### Staff Report to the **Agricultural Policy Advisory Commission**

Application Number: 05-0629

Project Description: Proposal to demolish an existing gas station and construct a replacement gas station and convenience store with beer and wine sales, install five gas pumps, construct a car wash, and re-configure the parking lot.

### COUNTY OF SANTA CRUZ DISCRETIONARY APPLICATION COMMENTS

SITE PLAN

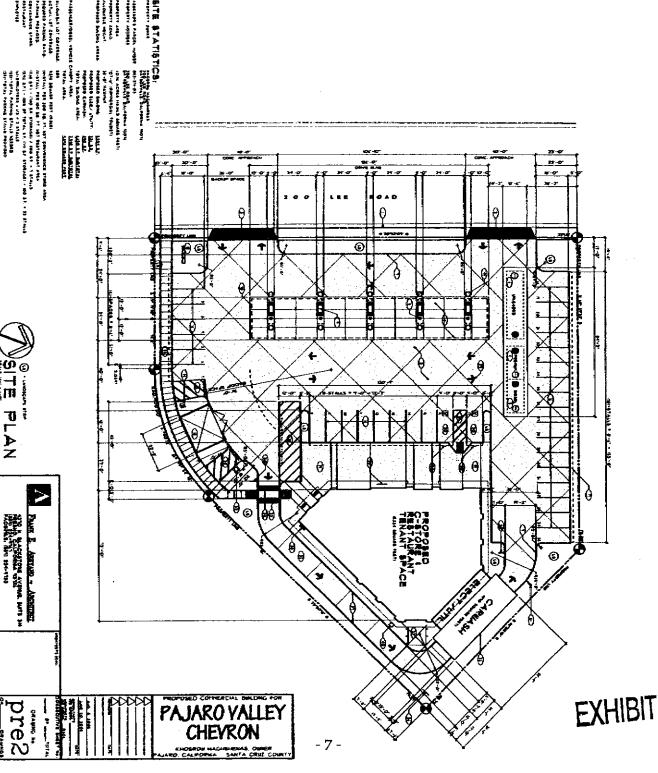
As can be seen from the table, the proposed canopy remains at about the same distance from the Willoughby property, but it is 30-feet closer to the Redmond property. The site plan also indicates that the width of the canopy facing the Willoughby property will increase from 24-feet to 136-feet. The proposed building exceeds the 200-foot buffer requirement from the Willoughby property but it reduces the existing setback from the Redmond property to less than 8-feet. The portion of the building closest to the Redmond property is the proposed car wash structure. There is virtually no change to the extent of the paved area on the property.

Finding 3: The gas station structure is proposed to be set back about 8 feet from the adjacent Commercial Agriculture zoned lands (the 15.6-acreRedmond Foundation organic farm). *Also*, the use within the rear area of the building consists of a car wash, resulting in higher public activity levels very close to CA land. No physical barriers are proposed to separate the uses other than ordinary chain link fencing and a narrow strip of low level landscaping. This is an inadequate physical barrier to supplant the required 200-foot buffer.

Finding 4: **This** finding cannot be made because alternatives have not been explored to provide the maximum buffering possible. These alternatives must include a review of site designs and barrier installations to provide the greatest possible setback distance from the agricultural land. As proposed, the service station is located as close to the Redmond organic farm property as possible (less than 8-feet from the agricultural land) with no adequate physical barriers.
